# ***Village of Lemont***

## **PLANNING AND ZONING COMMISSION**

**March 4, 2020 – 6:30 PM**

**TO:** Planning & Zoning Commission  
**FROM:** Jamie Tate, AICP, Consulting Planner  
**THRU:** Mark Herman, MPA, AICP, Community Development Manager

# GRADING & UTILITY PLAN

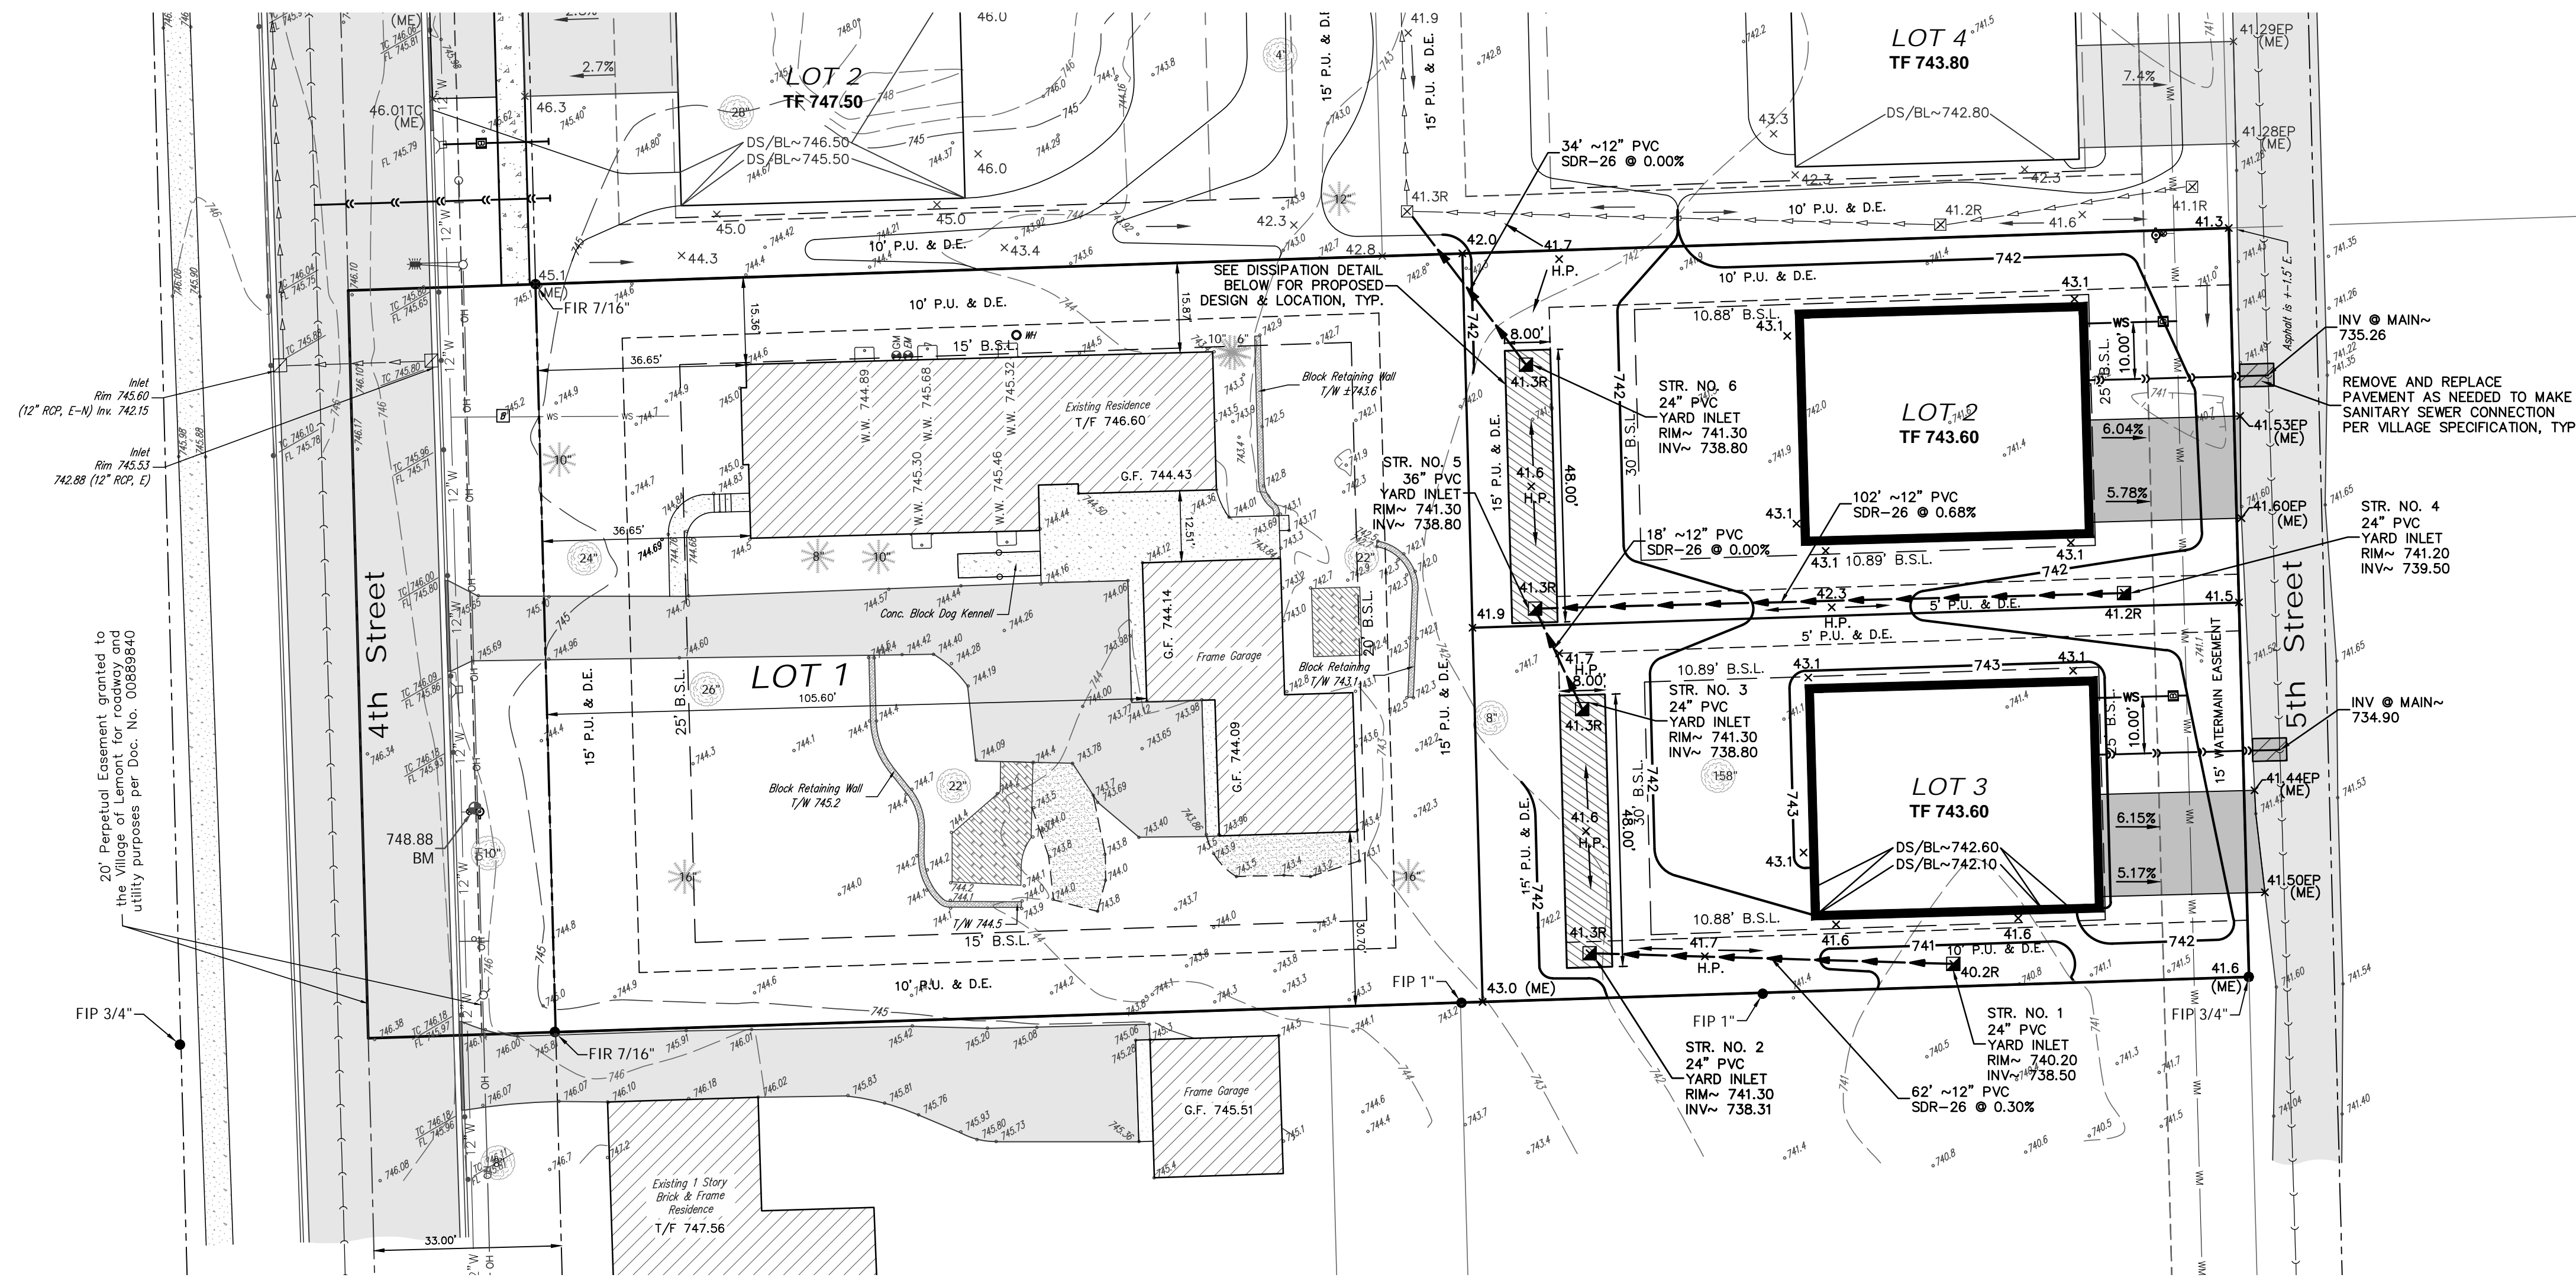
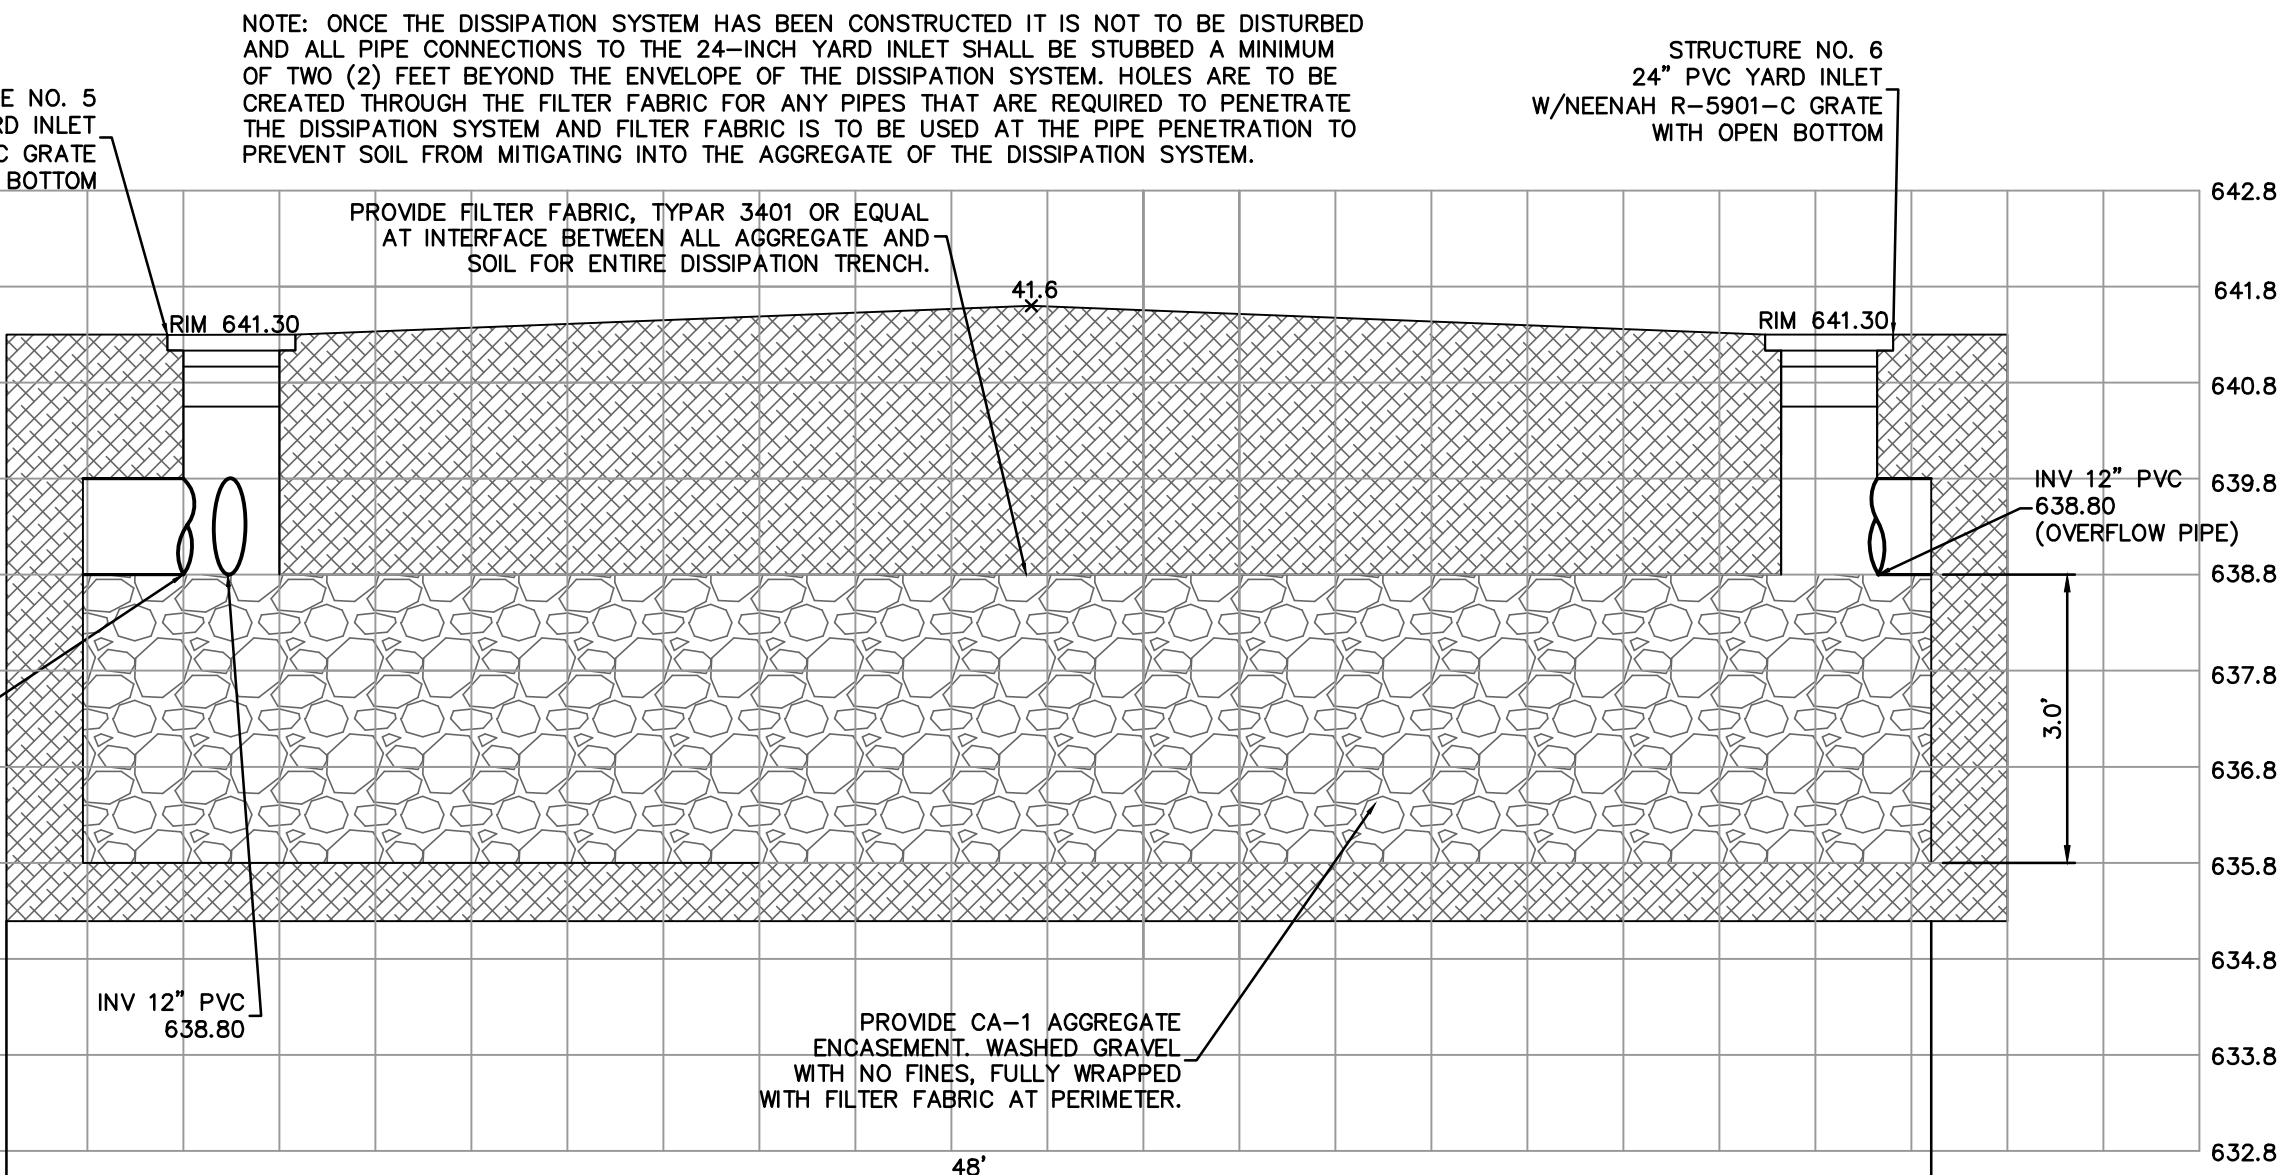
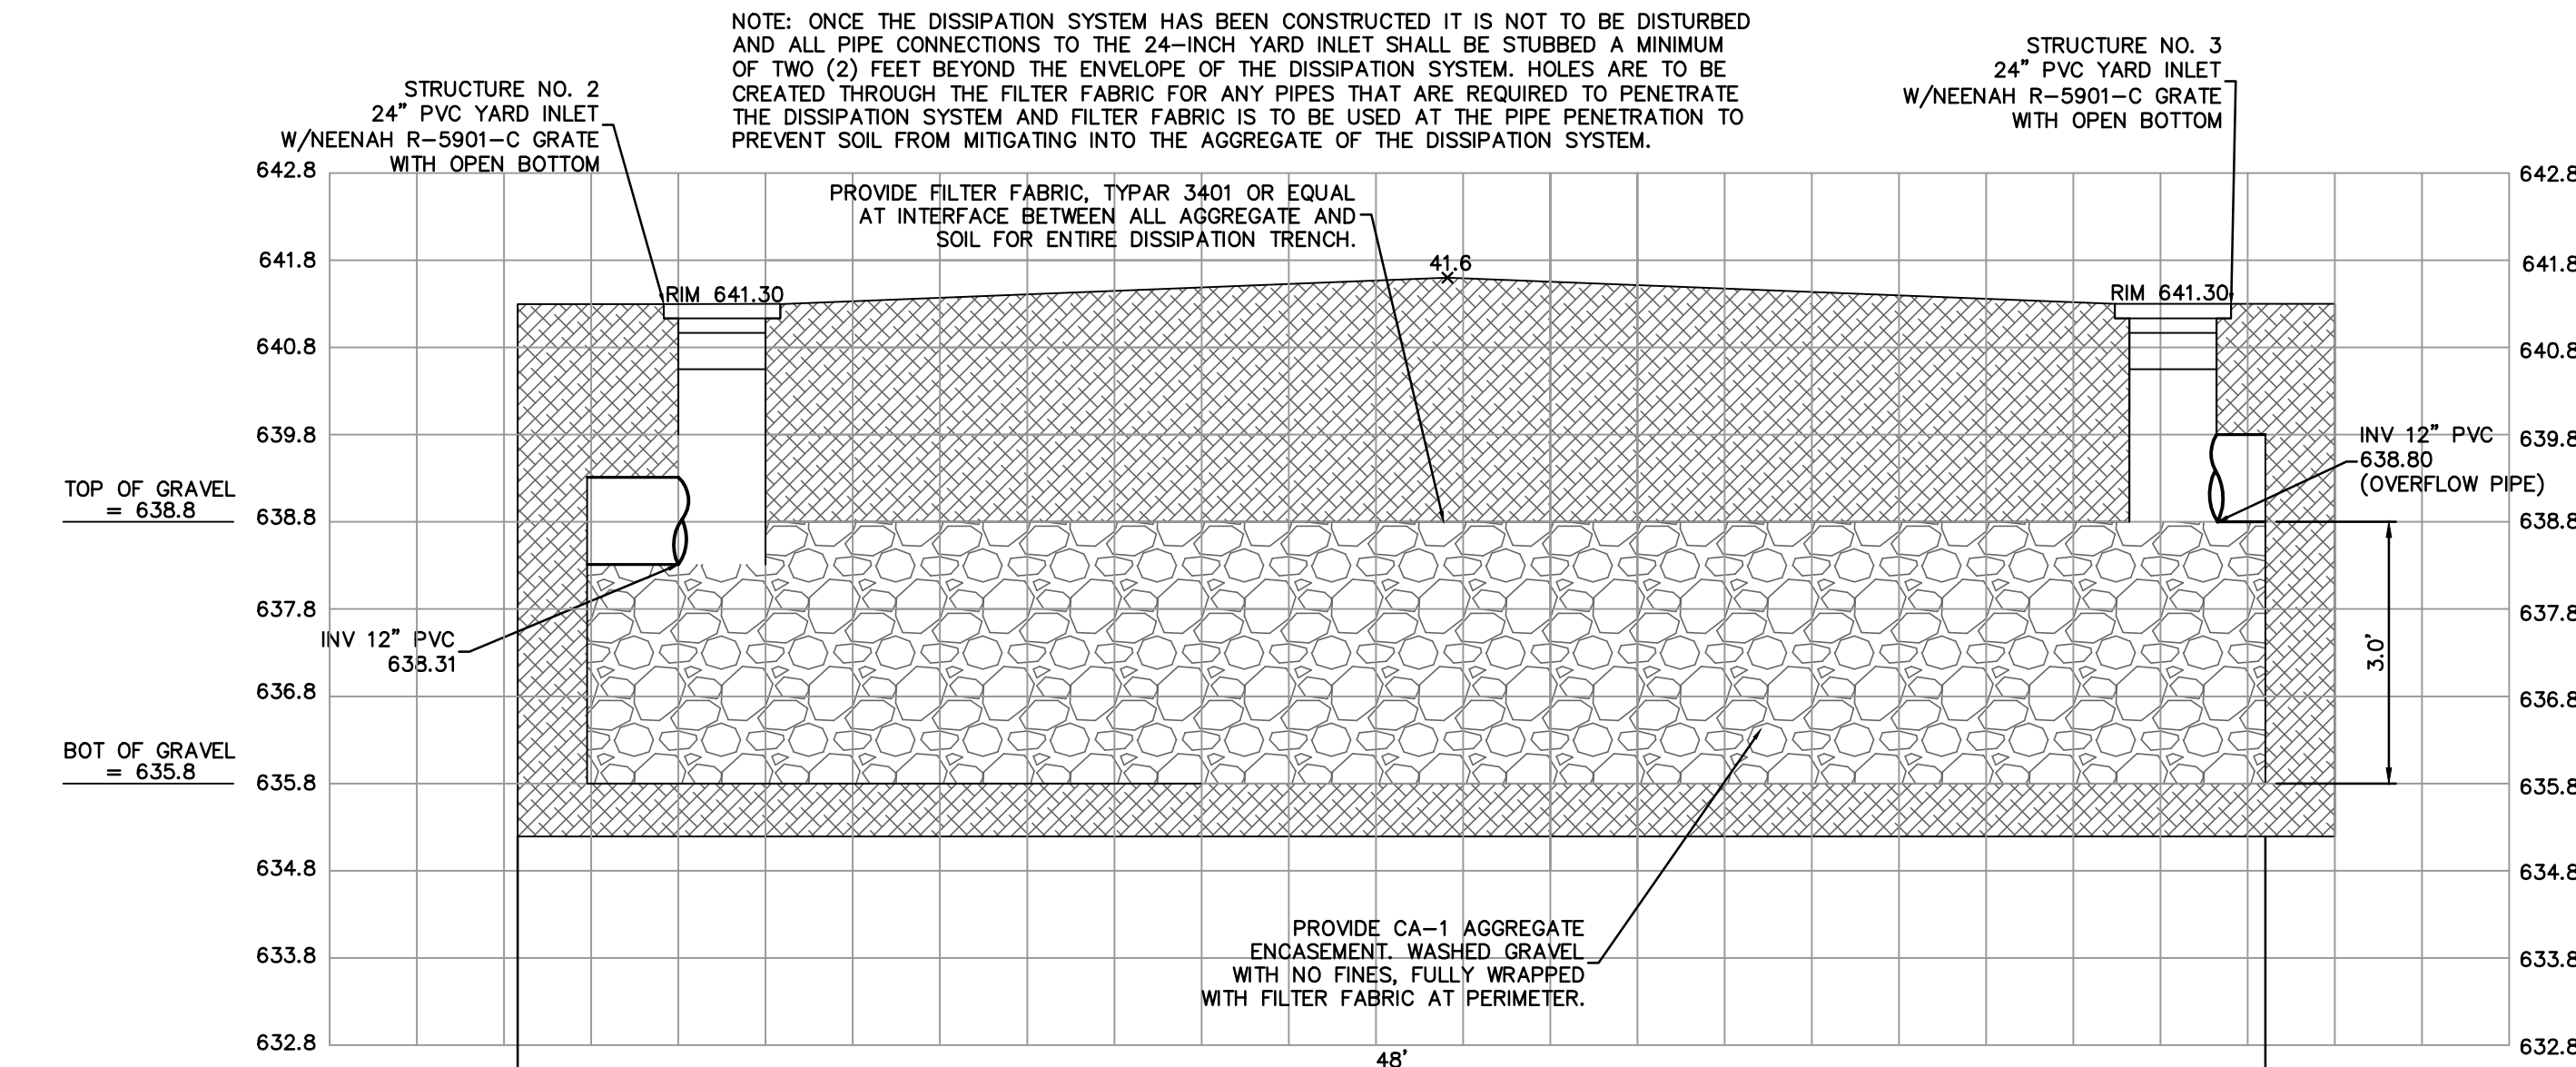
**Engineering.** The Village Engineer reviewed the plat and engineering documents and provided comments to the applicant. The engineer stated the final plat appears acceptable but had comments on the engineering plan. He believes there is a sewer/water conflict where the new sanitary sewer crosses under/over the existing water main on 5<sup>th</sup> Street and asked for clearance. There is also a comment regarding the sanitary sewer stub and ensuring it is located on or relocated into a PU & DE. The Village Engineer comment letter is provided in the attachments.
